# Stormwater Division

**General File ID or BMP ID:** 99123

Saint Bedes Catholic Church

### SITE PLAN AMENDMENT FOR RECTORY AND PARKING EXPANSION (AMENDMENT TO SP-28-01)

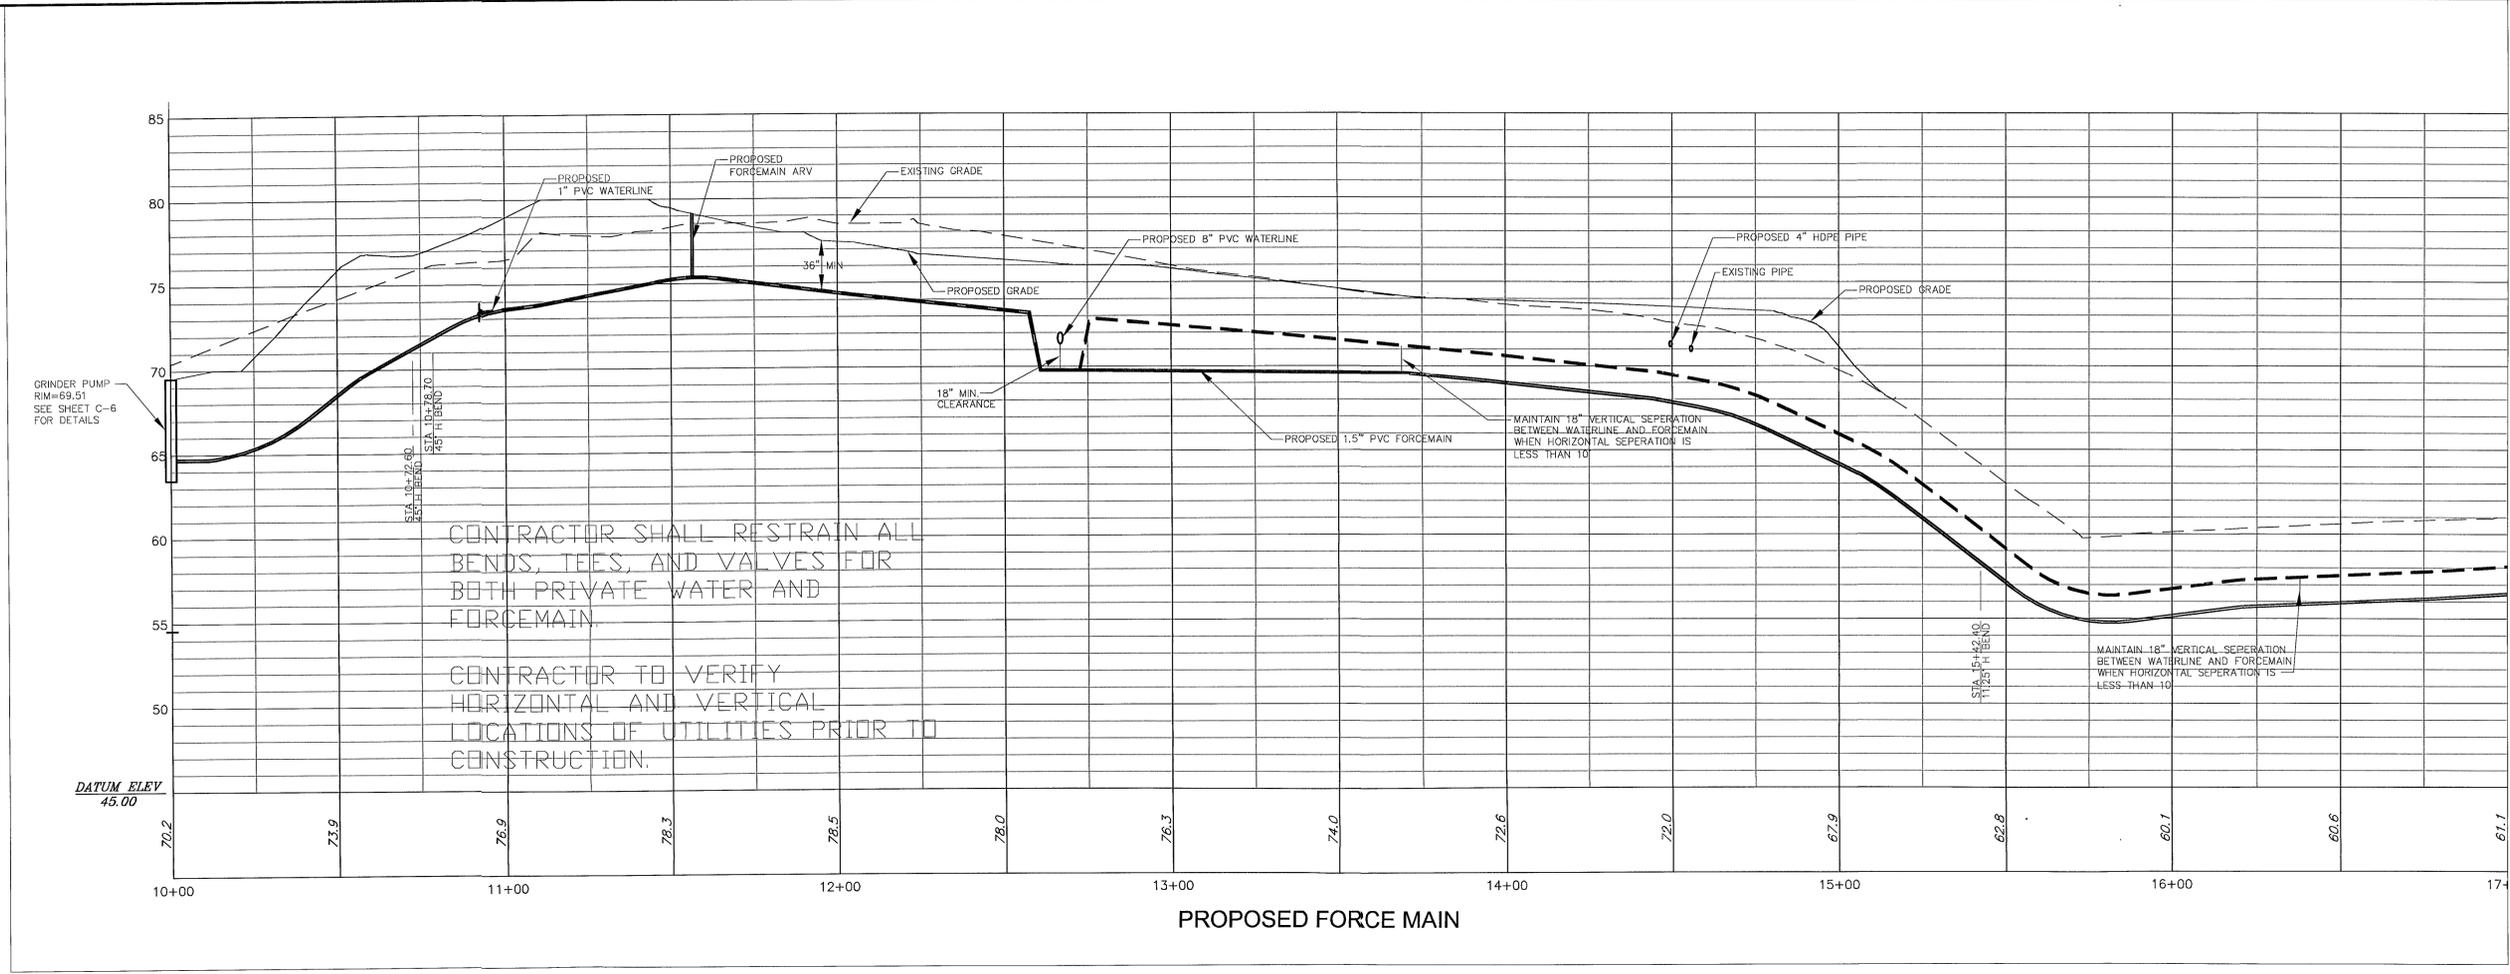
8. Manufactured BMP. Manufacturer's information was provided to address previous comment # 24. Based on our review of the literature and technical specifications for the proposed unit, a note is required to be placed on BMP section details on Sheet C-4A to indicate that subgrade (base of excavation), geotextile, bedding, compaction, backfill, cover and utility marker installation shall meet manufacturer's specifications and that all unrelated construction traffic shall be kept away from the limits of excavation until the project is complete and final surface materials are in place.

- 24d. Provide a maintenance plan on Sheet C-4, consistent with manufacturer’s recommendations.
  - 24e. Show minimum cover required from grade to top of the tank units.

23. Drainage from the side yard is directed toward the pavement on the rear side of the Rectory and into the manufacturer BMP.
24. Manufacturer's information packet has been provided as requested. The raintank storage area was designed with no infiltration intended. Maintenance plan provided on sheet C-4A. Minimum cover has been labeled over the raintanks.

25. We are not proposing infiltration for the manufactured BMP. We are releasing the 2- and 10-year storm at or below the pre-development rates.
26. A second section has been included on the plans on sheet C-4A.

- 24d. ✓ Provide a maintenance plan on Sheet C-4, consistent with manufacturer's recommendations. *C-4A*
- 24e. ✓ Show minimum cover required from grade to top of the tank units. *1/2" DETAILS*

# ENVIRONMENTAL INVENTORY

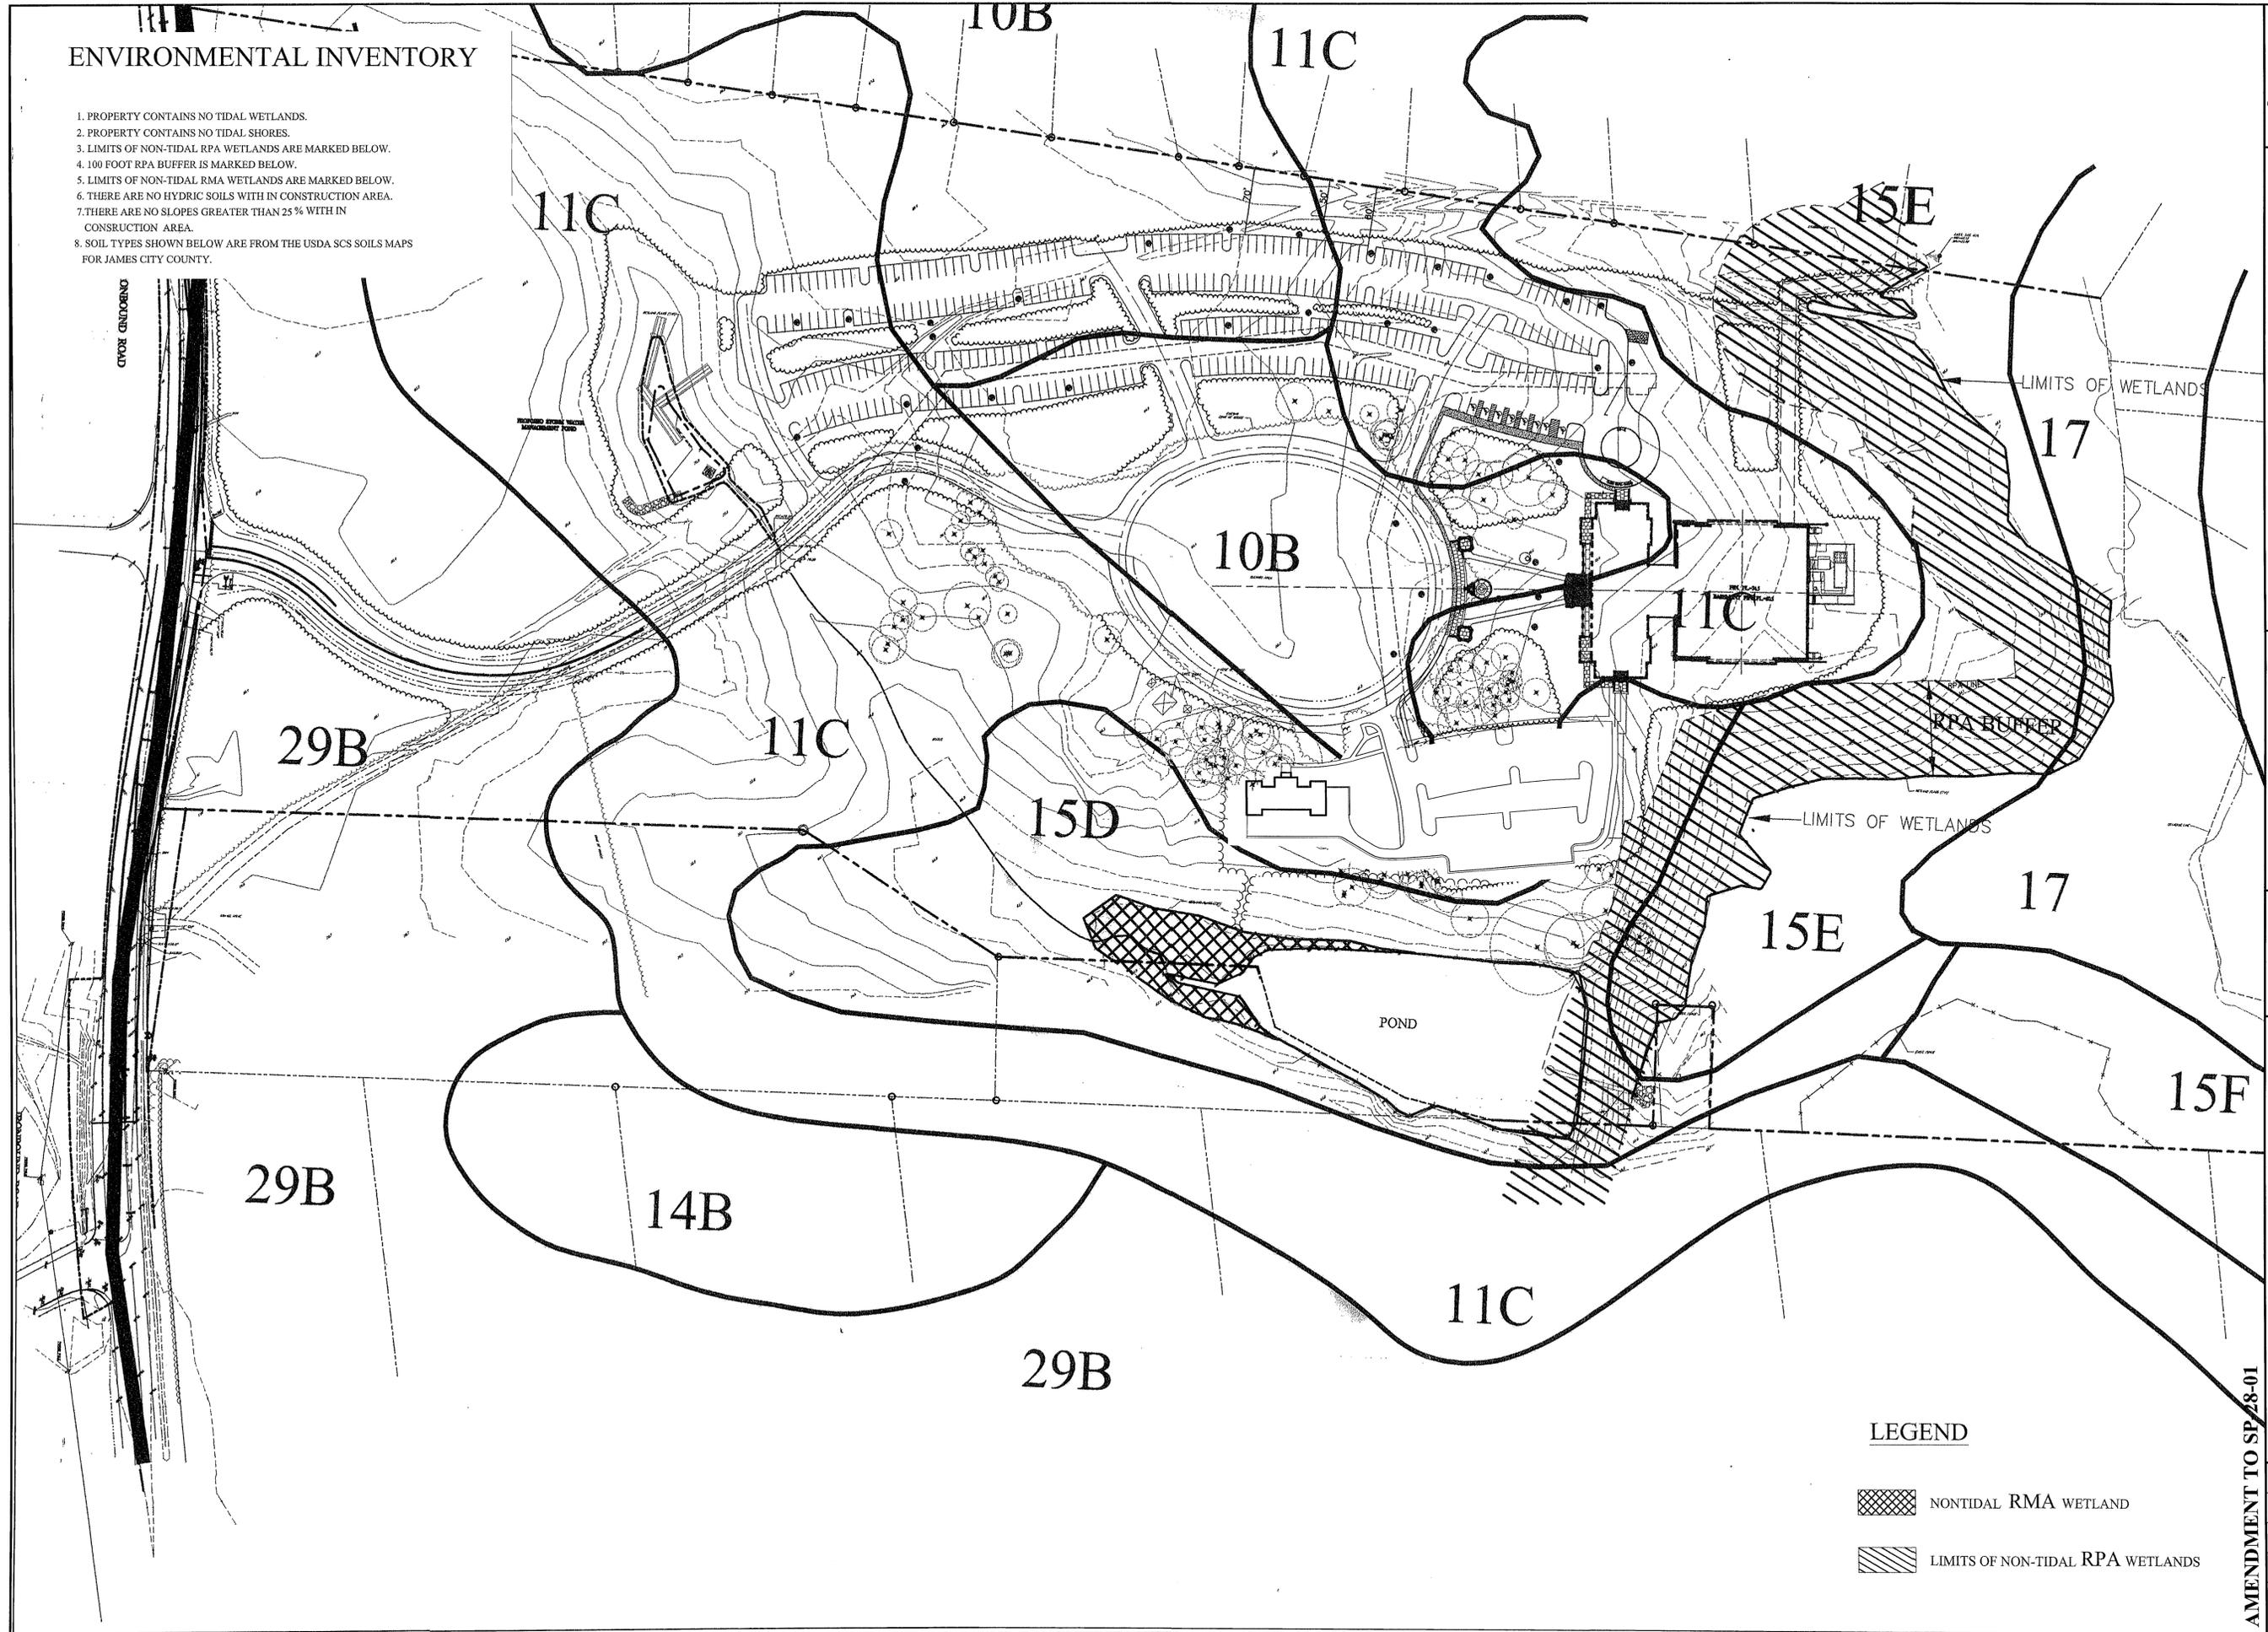
4. An environmental inventory is required for this project and was not provided. Provide an environmental inventory in accordance with Section 23-10(2) of the Chesapeake Bay Preservation ordinance. *(Note: A simple table, showing the components required per the ordinance and whether or not there are impacts, and reference to the "parent" inventory as completed under SP-18-03, can be added to Sheet C-3.)*

1. Acknowledged.
2. Acknowledged.
3. Acknowledged.
4. Environmental Inventory is located on sheet C-5.
5. Design checklist has been included in the calculation book.

Sheet C-5 OK.
